The Commission has issued the enclosed Amendment No. 49 to Facility Operating License No. DPR-24 and Amendment No. 55 to Facility Operating License No. DPR-27 for the Point Beach Nuclear Plant, Unit Nos. 1 and 2, respectively. The amendments consist of changes to the Technical Specifications in response to your application transmitted by letter dated December 19, 1979 and modified by letter dated February 3, 1981.

AMENDMENT NO. 49 TO FACILITY OPERATING LICENSE NO. DPR-24

AMENDMENT NO. 55 TO FACILITY OPERATING LICENSE NO. DPR-27

SAFETY EVALUATION BY THE OFFICE OF NUCLEAR REACTOR REGULATION
SUPPORTING AMENDMENT NO. 49 TO FACILITY OPERATING LICENSE NO. DPR-24
AND AMENDMENT NO. 55 TO FACILITY OPERATING LICENSE NO. DPR-27
WISCONSIN ELECTRIC POWER COMPANY
POINT BEACH NUCLEAR PLANT, UNIT NOS. 1 AND 2
DOCKET NOS. 50-266 AND 50-301

FIGURE 15.3.10-1
 CONTROL BANK INSERTION LIMITS
 POINT BEACH UNITS 1 AND 2

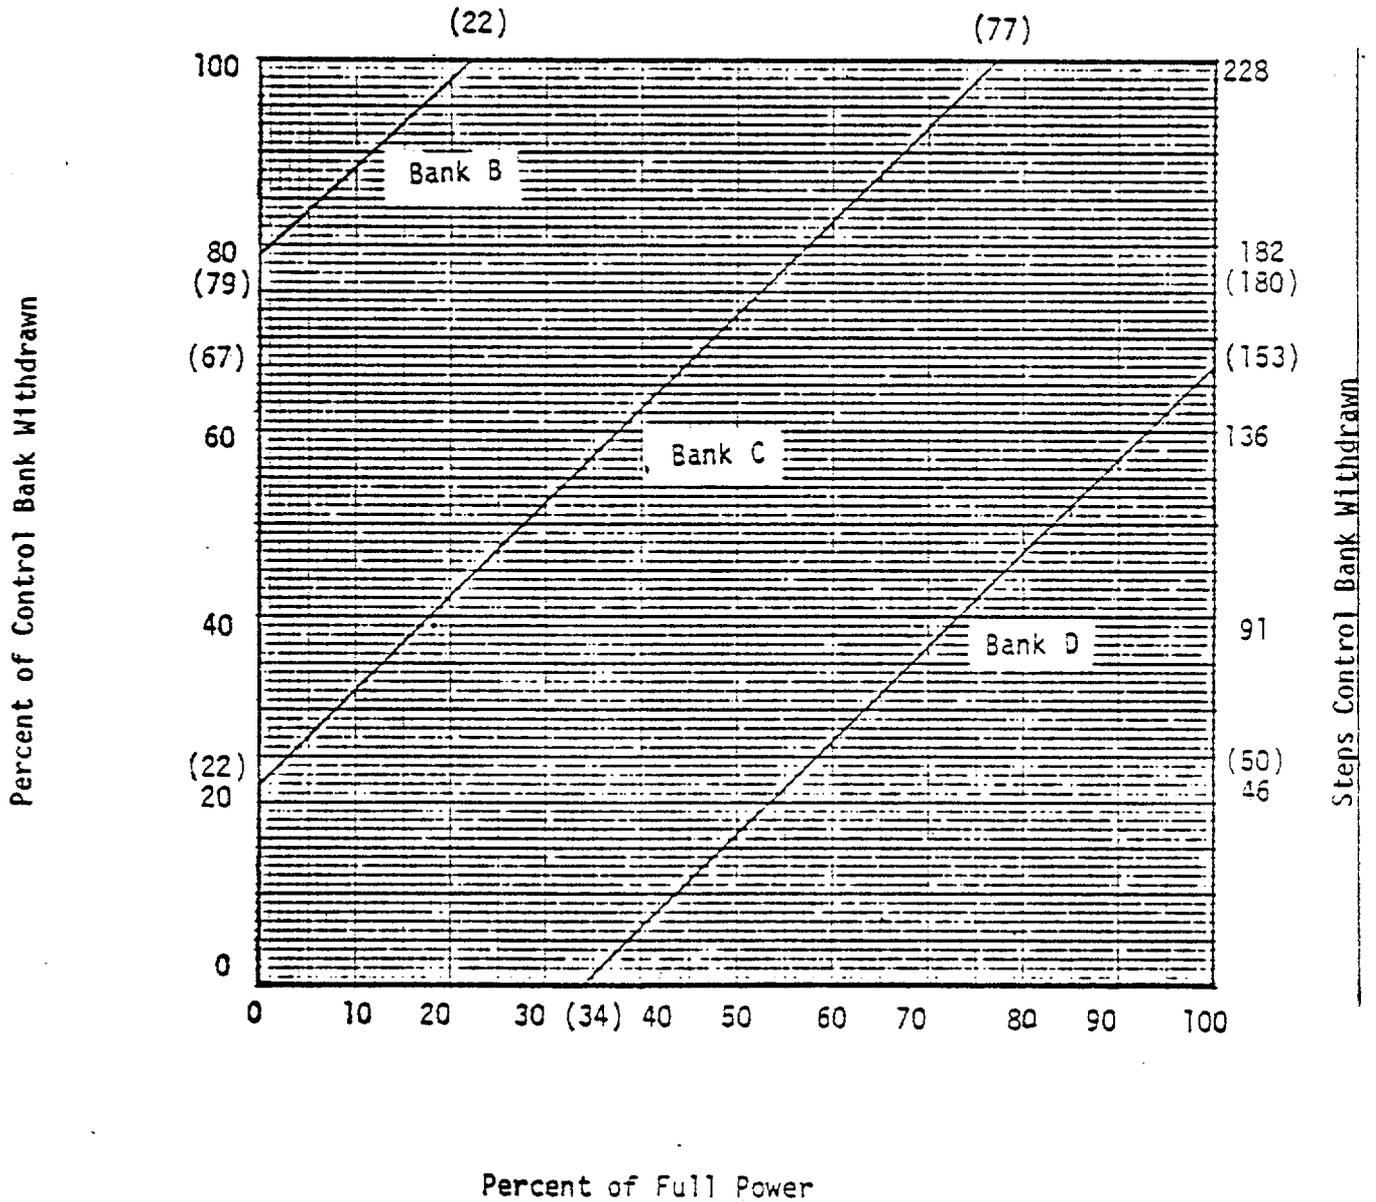
When the insertion limits are observed and the control rod banks are above the solid lines shown on Figure 15.3.10-1, the shutdown requirement is met. The maximum shutdown margin requirement occurs at end of core life and is based on the value used in analysis of the hypothetical steam break accident. Figure 15.3.10-2 shows the shutdown margin equivalent to 2.77% reactivity at end-of-life with respect to an uncontrolled cooldown. All other accident analyses assume 1% or greater reactivity shutdown margin. Shutdown margin calculations include the effects

2. Control rod banks are sequenced with overlapping banks as described in Figure 15.3.10-1.
3. The full-length control bank insertion limits are not violated.
